SERVICE BULLETIN BI

BUCII
AMERICAN MOTORCYCLES

B-035 October 6, 2000

SHOCK ABSORBER AND FRONT SHOCK MOUNT

Figure 2. New Shock Absorber Assembly

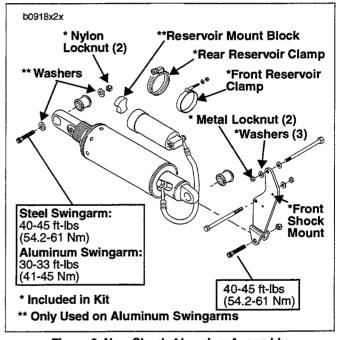
The new front shock mount MUST be used with the new shock absorber. The new shock is 1.77 in. (45 mm) shorter than the previous shocks and requires the new front mount to align and install properly.

- See Figure 2. Install new front shock mount to crankcase with two new front shock mount bolts, washers, star washer (on 1997 M2, S3/S3T models only) and metal locknuts. Tighten bolts to 30-33 ft-lbs (41-45 Nm). NOTE: Top bolt goes in from the left side, bottom bolt goes in from right side. Bottom bolt does not use washer under bolt head. Star washer (only used on 1997 M2, S3/S3T models) goes on bottom bolt under the washer on the nut side. If exhaust was loosened during front shock mount removal, replace exhaust gaskets and reinstall exhaust. See appropriate Service Manual, Section 2 for instructions.
- All Models Except S1/ S1W/S2/S2T: Apply LOCTITE THREADLOCKER 243 (Blue) to threads of new button head fastener. Fasten voltage regulator bracket to front shock mount with new small button head fastener. Tighten fastener to 5-6 ft-lbs (7-8 Nm).

- 4. See Figure 2. Position **new** shock absorber from kit in mounting position.
- 5. Loosely install bolt, washers (aluminum swingarms only) and **new** locknut through rear shock eye and swing arm.
